Indian Point Energy Center
450 Broadway, GSB
P.O. Box 249
Buchanan, N.Y. 10511-0249
Tel (914) 734-6700

Re: Indian Point Unit 2
Docket 50-247

NL-08-106

SUBJECT: Reply to Request for Additional Information Regarding Surveillance Requirements For ECCS Valves Required to be in Position with Power to the Valve Operator Removed (TAC MD7501)

STATION: INDIAN POINT
DRAWING NO: A235296-
MY

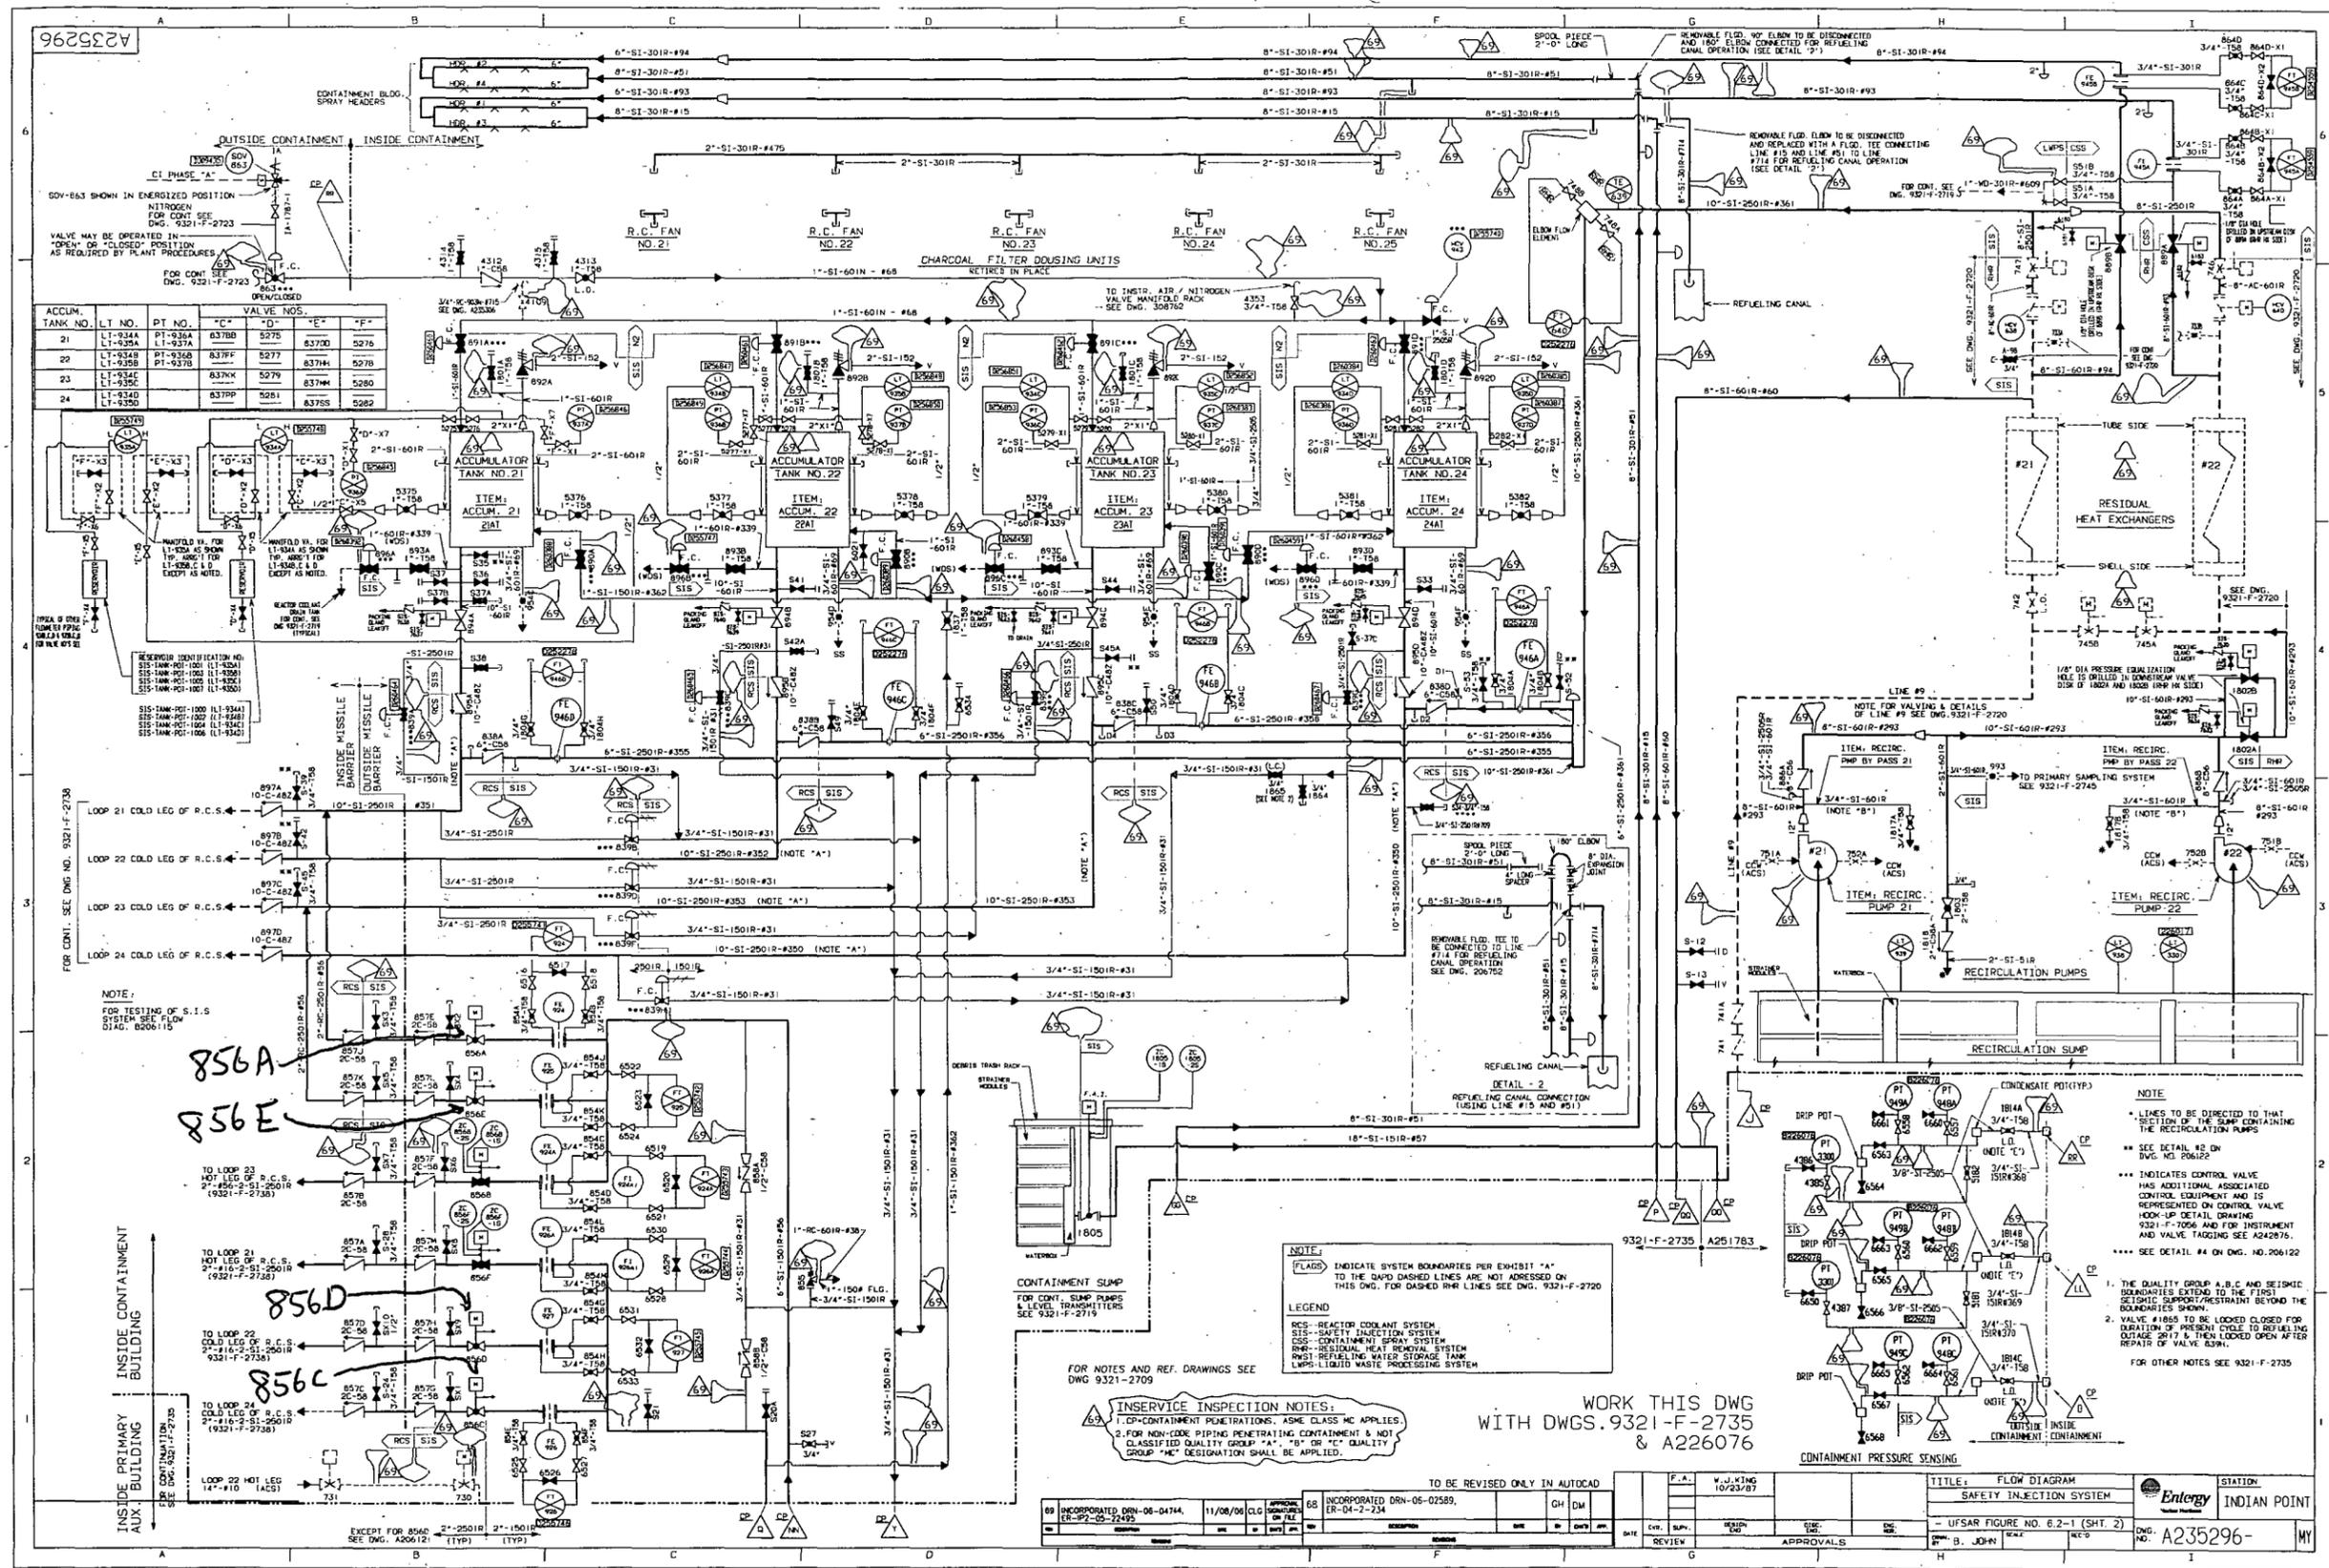
Please provide flow diagrams for the systems in which the subject seven valves are located. Identify the valves in the diagrams.

Enclosure 1 contains three drawings. Drawing A235296 has been marked to show the locations of valves 856A, 856C, 856D and 856E which are proposed to be removed from the Technical Specification. Drawing 9321-F-2735 has been marked to show the locations of valves 1870 and 883 which are proposed to be added. Drawing A251783 has been marked to show the locations of valves 883, 1870 and 743 which are proposed to be added.
